Technical Bulletin

Number 112
June, 1979

C-SERIES SIDESHIFTER OPERATING SPEED

Models Affected: 30C and 55C Sideshifters dated prior to 5/79
(5th week of 1979; date is stamped on cylinder)

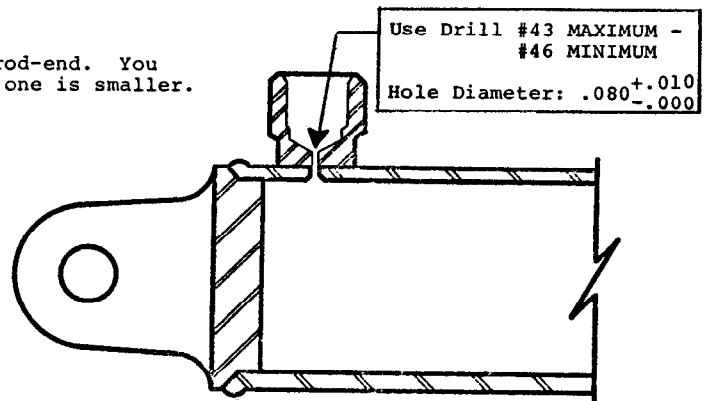
Operating speeds on Cascade Model 30C and 55C Sideshifters have been increased by enlarging the port opening from .060 inches to $.080^{+.010}_{-.000}$ inches on current production units. This increased port opening provides a significant increase in operating speed.

Sideshifters presently in the field may also be modified to achieve this increase in operating speed by increasing the port* opening from .060 inches to $.080^{+.010}_{-.000}$ inches.

* This port opening may be at the base-end or the rod-end. You must check both port openings to determine which one is smaller. The smaller one is the one to drill.

To make this field modification, disassemble the cylinder and enlarge the port opening, using a #43 drill bit (Maximum) - #46 drill bit (Minimum) Refer to the Sideshifter Service Manual, Form 5142, for the complete disassembly instructions.

CAUTION: Prior to reassembly, carefully inspect the inside of the shell and remove any burrs with a butterfly hone. Thoroughly clean the inside of the shell. Burrs, shavings or metal dust in the cylinder will destroy the packings and can damage the complete cylinder.

WARNING: DO NOT INCREASE THE PORT OPENING BEYOND THE MAXIMUM .090 INCH DIAMETER RECOMMENDED BY CASCADE. Port hole diameters exceeding this dimension will allow the sideshifter to operate at excessive speeds. This will affect the trucks stability during high lift operations.
